Responsible: U. Laarmann  
Date: 23.05.2006

### KD12450.O E and KD9450.O E: burned ribbon cable

Old model before removal

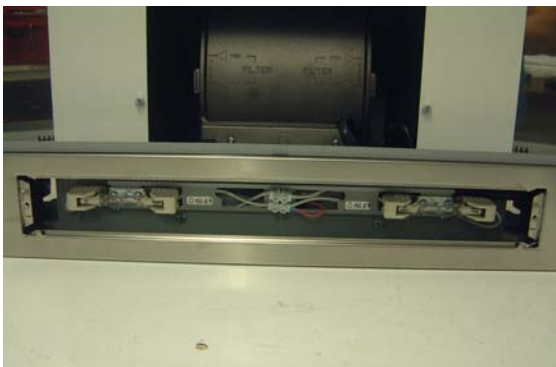
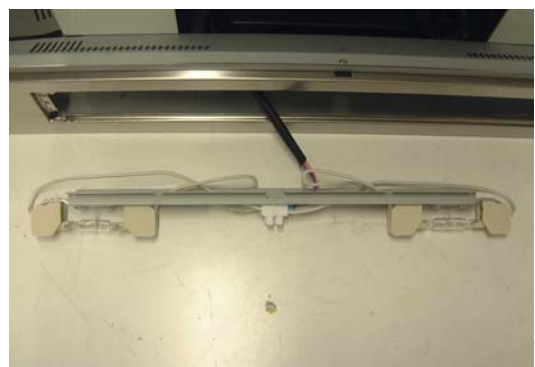
When the lamp of the hood operates constantly, the heat given off by the 60W/240V halogen lamps may cause the ribbon cable (spare-part no. 56 54 77) between the electronics unit and the control unit to burn, resulting in various problems with the controls.

The glass of the lamp will need to be removed before the new lamp bracket can be installed. Then loosen the screws of the lamp bracket and disconnect the electrical connection.

A repair kit can be ordered under spare-part no. 53 19 06 when problems like this occur. In this kit the 60W/240V halogen lamps have been replaced with 40W/240V halogen lamps and a lamp bracket.
